Customer information Nr. 007-2022

ALL FONTEMAGNA 150 230V and 115V
ALL FONTEMAGNA COMPACT 150 230V and 115V
ALL BLU2GO 230V and 115V

DETAILS: Technical improvements of pre-assembled INLET WATER GROUP

NEW INLET WATER GROUP FOR FONTEMAGNA 150

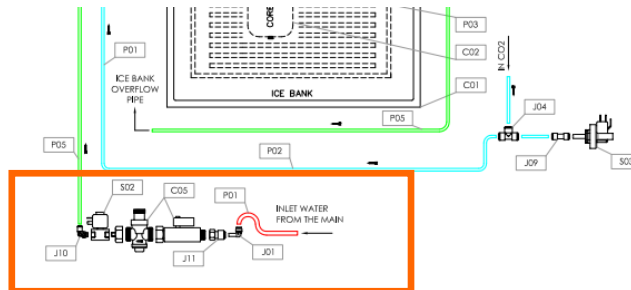
CHANGES PROPOSAL: Use of a modular INLET WATER GROUP with water pressure reducer preset at 3 bar and solenoid valve which complies with a wider range of international certifications for food-grade use.

Complete INLET WATER GROUP for the Fontemagna 150 Floorstanding model and Blu2Go;

INLET WATER GROUP w/out water pressure reducer for Fontemagna Compact 150.

Old code 800032 → New code PREASSEMBLED KIT **750321** for Fontemagna 150 Floorstanding Models

Old code 800042 → New code PREASSEMBLED KIT **750322** for Fontemagna Compact 150 Models

NEW HYDRAULIC DIAGRAM

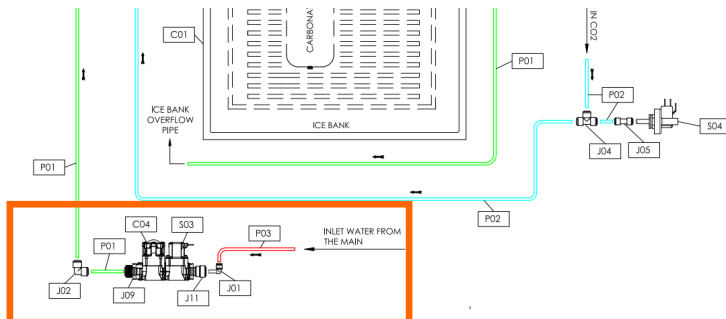
Completely removed on BOX 150/280 models.

The new INLET WATER GROUP is interchangeable with the old one.

NEW INLET WATER GROUP FOR BLU2GO

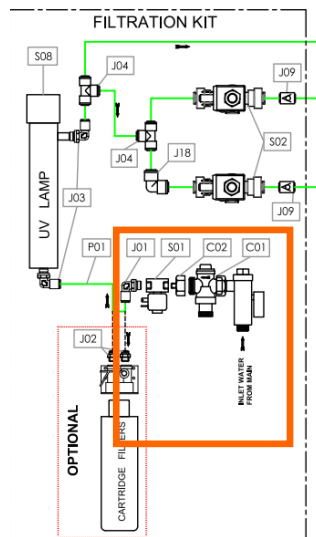
CHANGES PROPOSAL: Use of a modular INLET WATER GROUP with water pressure reducer preset at 3 bar and solenoid valve which complies with a wider range of international certifications for food-grade use.

Complete INLET WATER GROUP for the Fontemagna 150 Floorstanding model and Blu2Go.

Old code 800456 → New code PREASSEMBLED KIT **750323** for BLU2GO Models

NEW HYDRAULIC DIAGRAM

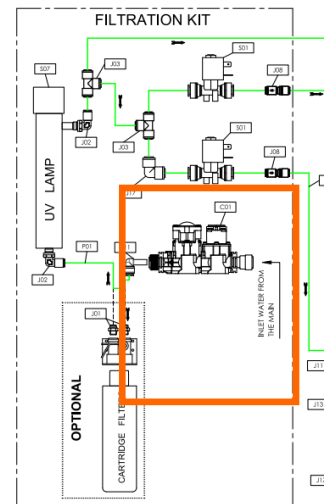
Completely removed on BOX 150/280 models.

The new INLET WATER GROUP is interchangeable with the old one.
